Louisville Revitalization Commission

SUBJECT: DOWNTOWN FRONT AND CENTER UPDATE

City Staff will provide an update to the LRC on the revisions and additions made to the Downtown Front & Center concept plan based on LRC feedback provided at the March 25th meeting. The project team has developed a full range of improvement options that can be selected and prioritized to fit within the available project budget in the attached revised concept plans. Presented below is a summary of major comments provided by LRC at the previous meeting and via email and an explanation of how those comments have been incorporated into the revised concept plans:

CITY OF LOUISVILLE FRONT & CENTER PROJECT REVISED CONCEPT PLANS

Spruce Street

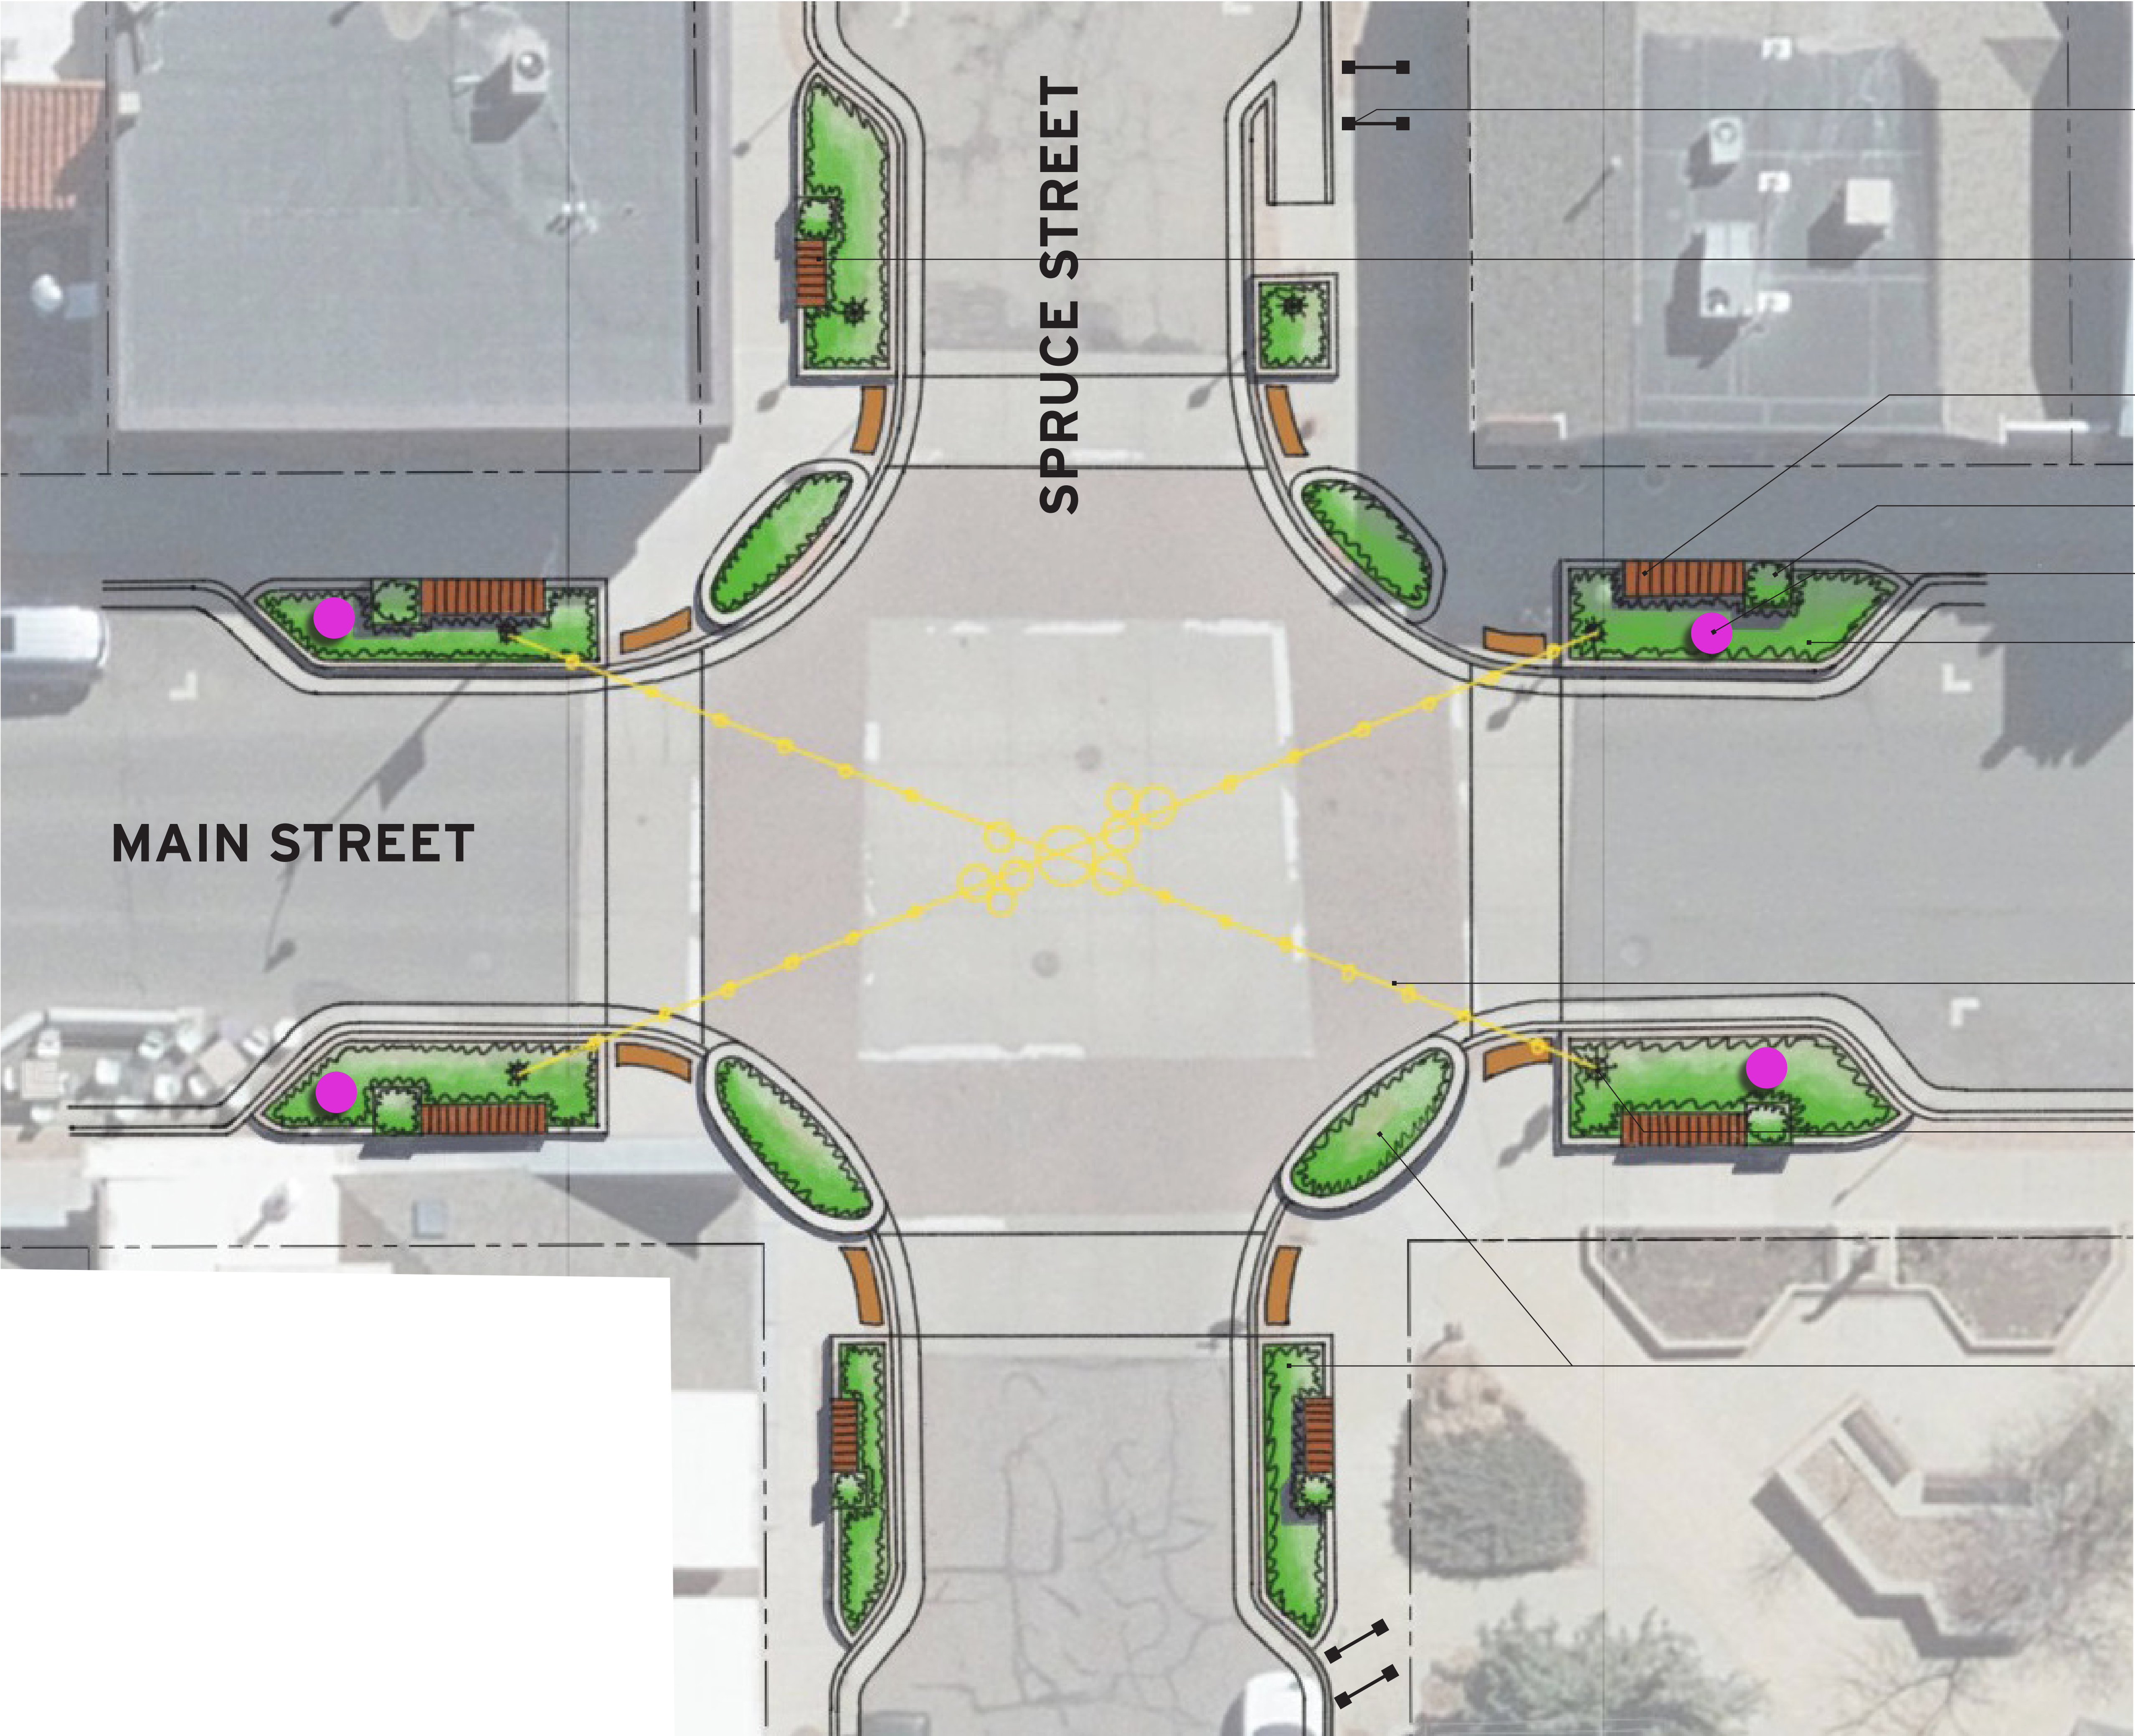
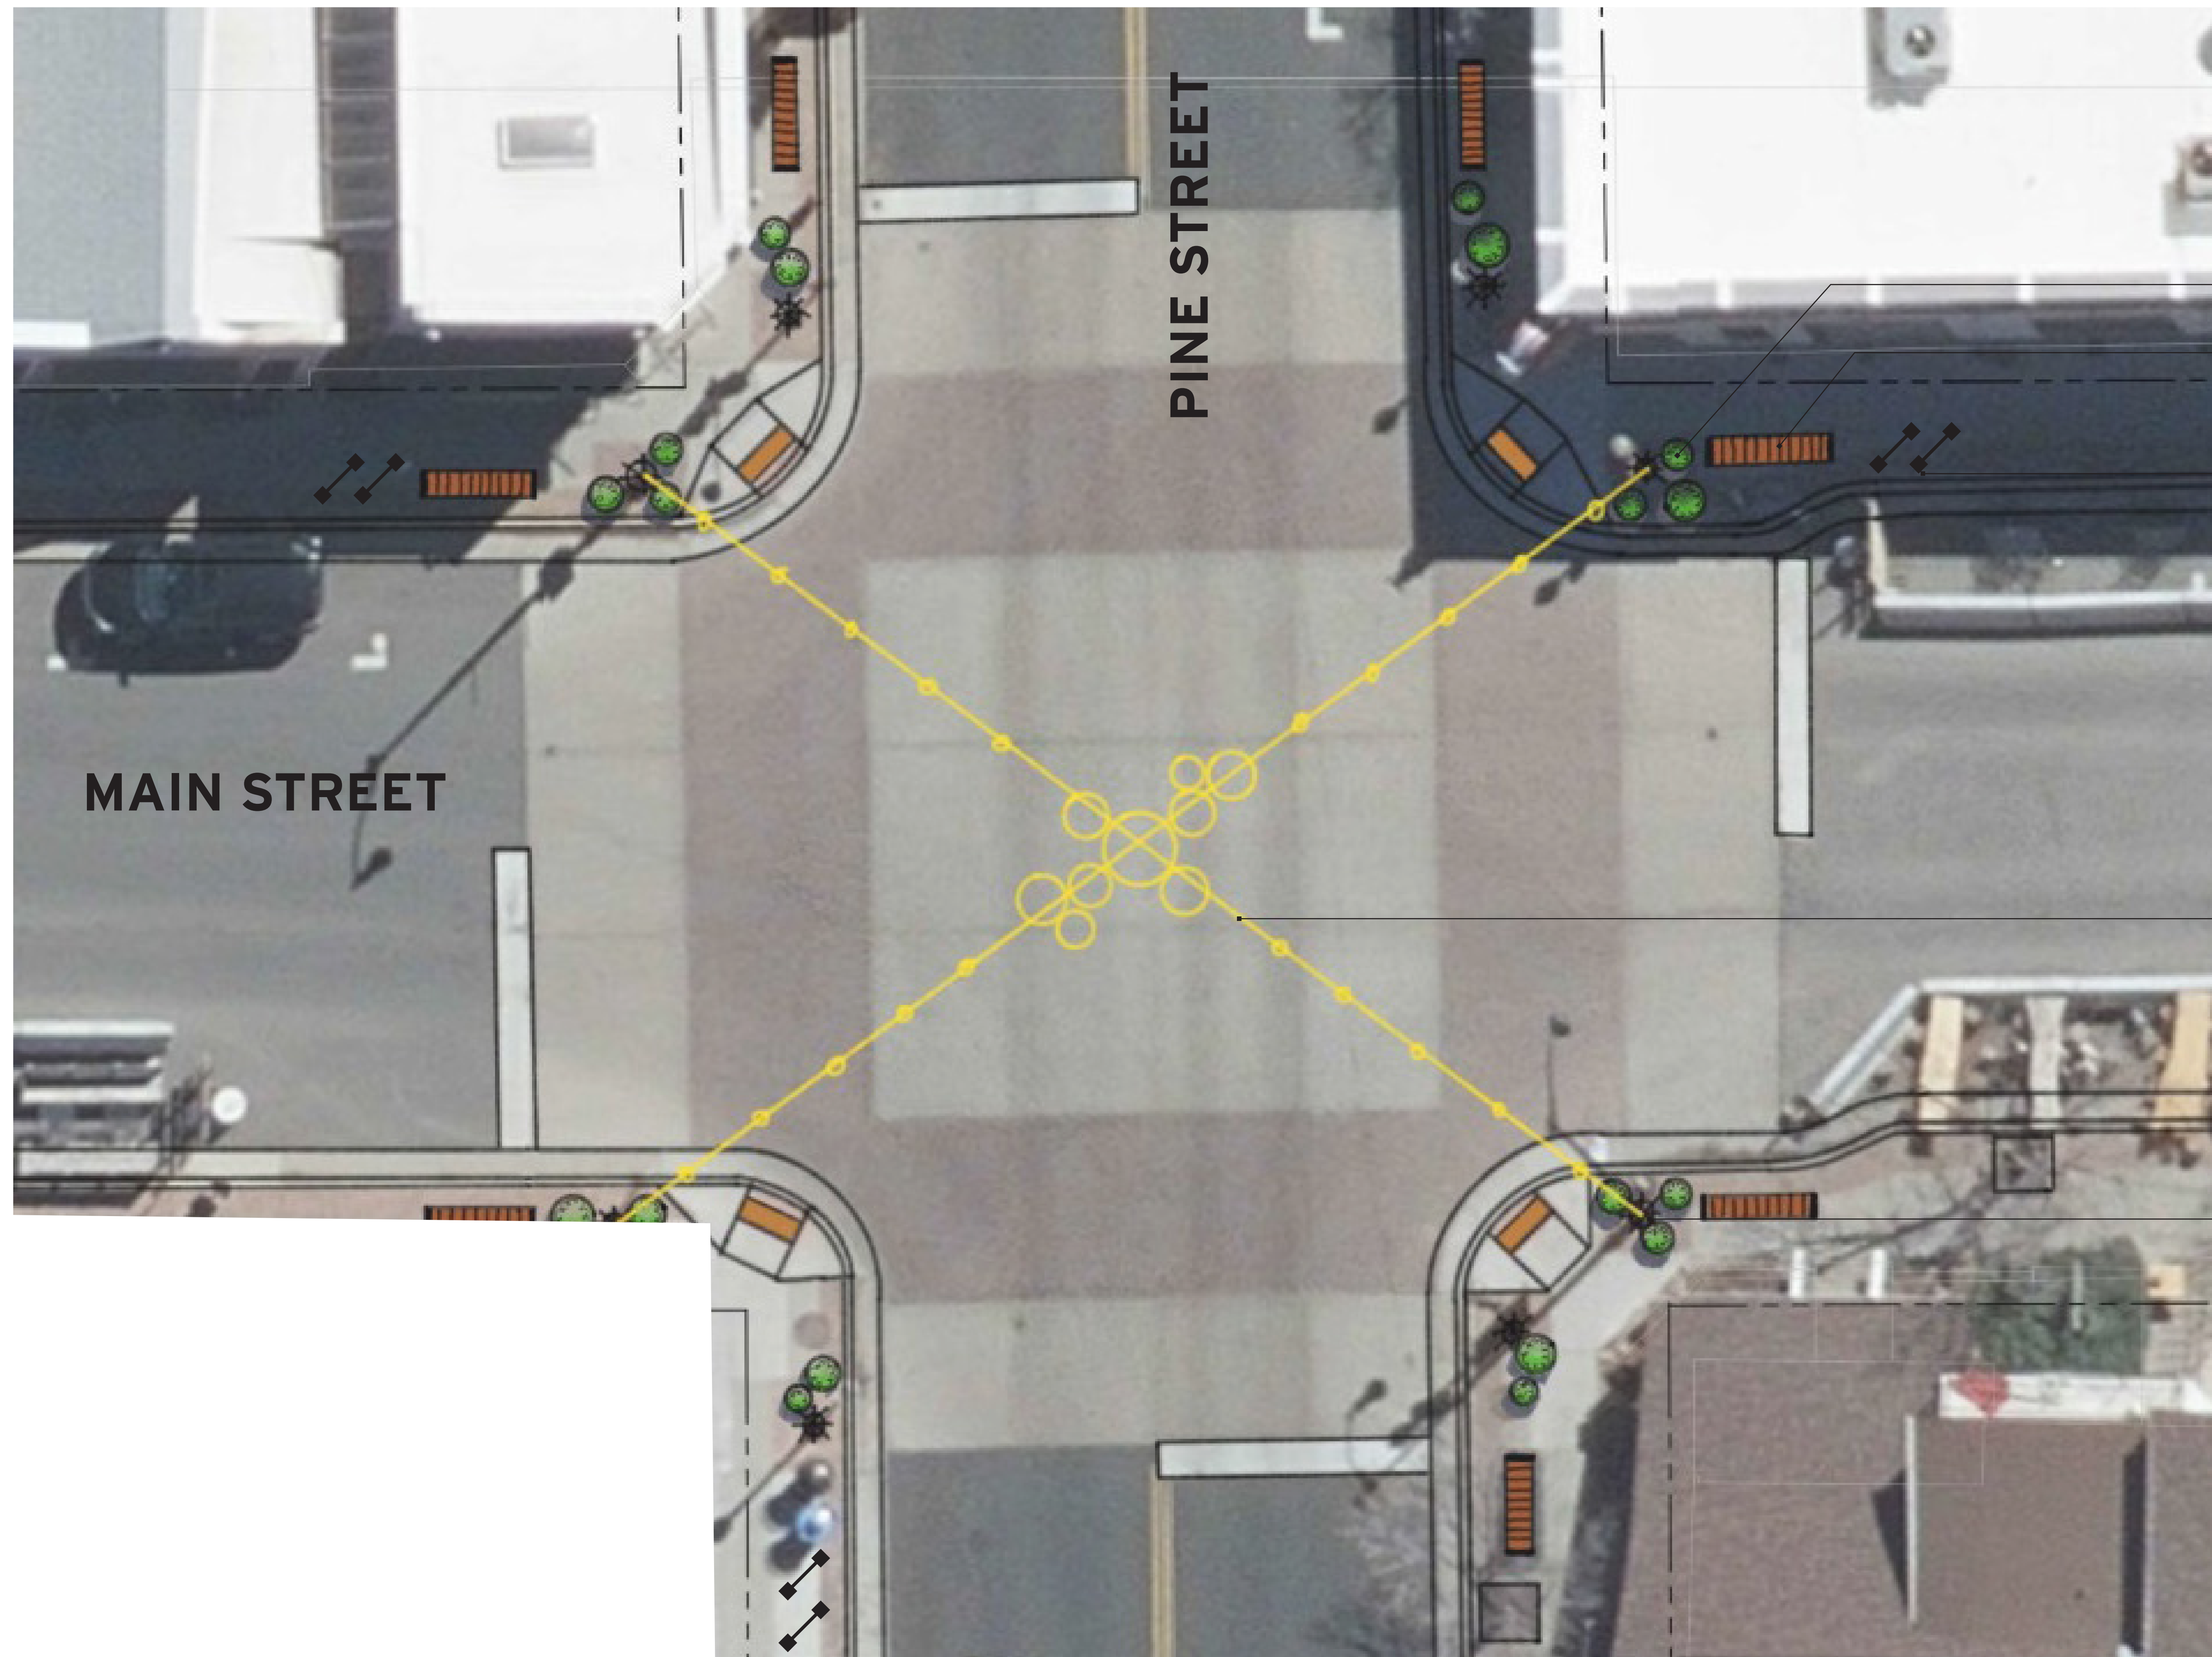
- Incorporate trees, landscaping, in-ground planters, and planter pot options at intersections.
 - *Landscaping options including in-ground planting and planters have been included for five (5) intersections along Main Street: South Street, Walnut Street, Spruce Street, Pine Street, and Elm Street. Plantings include deciduous shrubs, ornamentals, and perennials. Benches have also been provided at intersections. Concept plans for each intersection are provided in the conceptual design package. The estimated cost for these improvements is \$228,500 per intersection, or \$1,142,500 for all five (5) intersections. This does not include the costs for intersection lighting or street trees.*

- Provide bench seating near intersections.
 - *Bench seating has been included with the updated intersection landscaping plans and is included in the costs above in bullet #1. Additionally, an inventory of benches has been taken along the Main Street corridor for informational purposes and further planning.*

EXISTING SITE FURNISHINGS

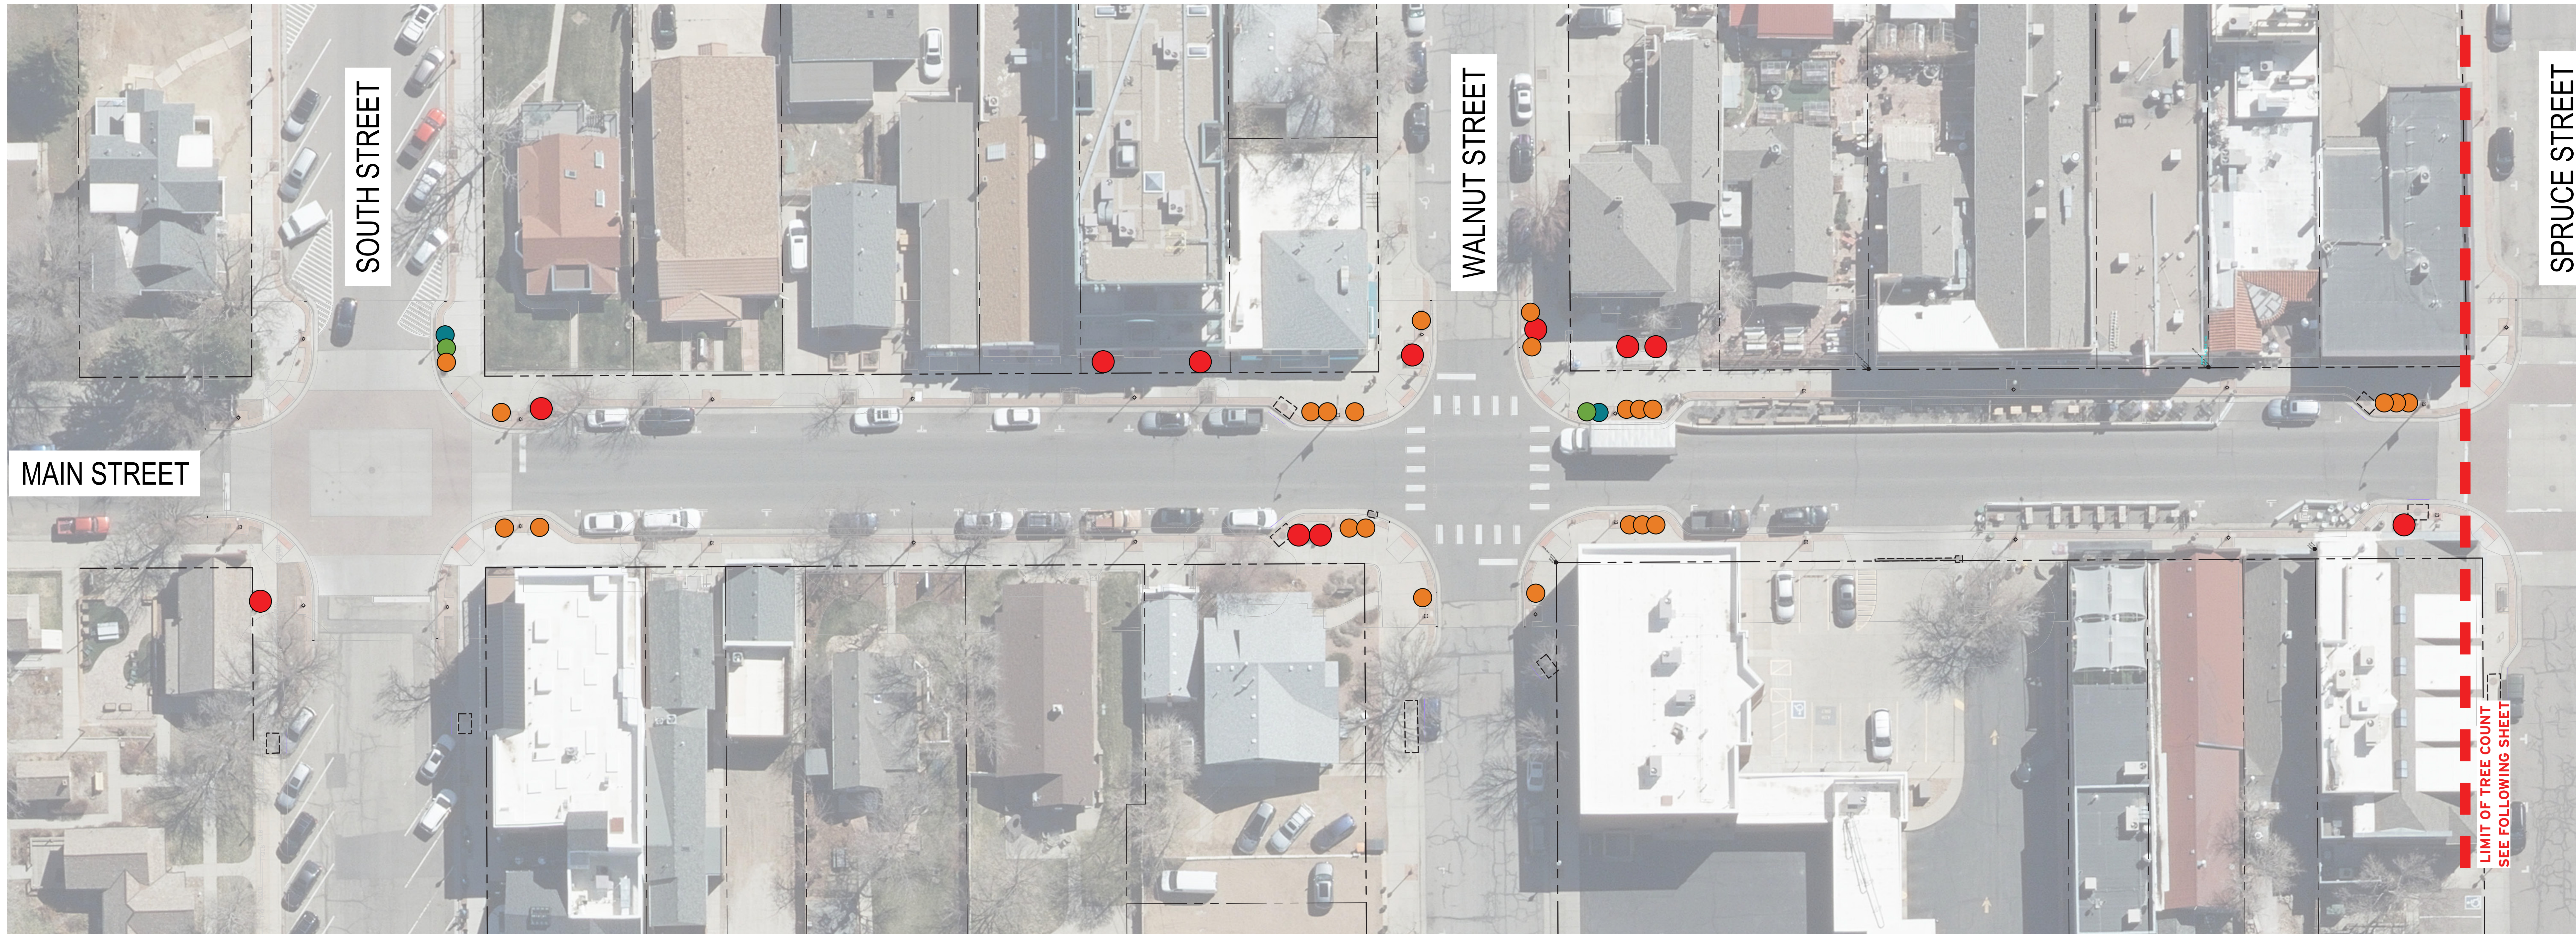
- Can we incorporate pockets of seating and/or mosaic street furniture or unique/colorful seating in front of City Hall, next to Waterloo, corner of Walnut, etc.

- Can we paint the existing benches or replace them with something more unique?
 - *This is possible and can be coordinated in the detailed design phase. Replacement of existing benches is not included in the current budget.*

- *Yes, a seating inventory has been taken and provided in the attached concept plans to aid in further discussions on seating. Seating has been proposed at several intersections as identified in the plans. Seating details will be further developed in the detailed design phase.*
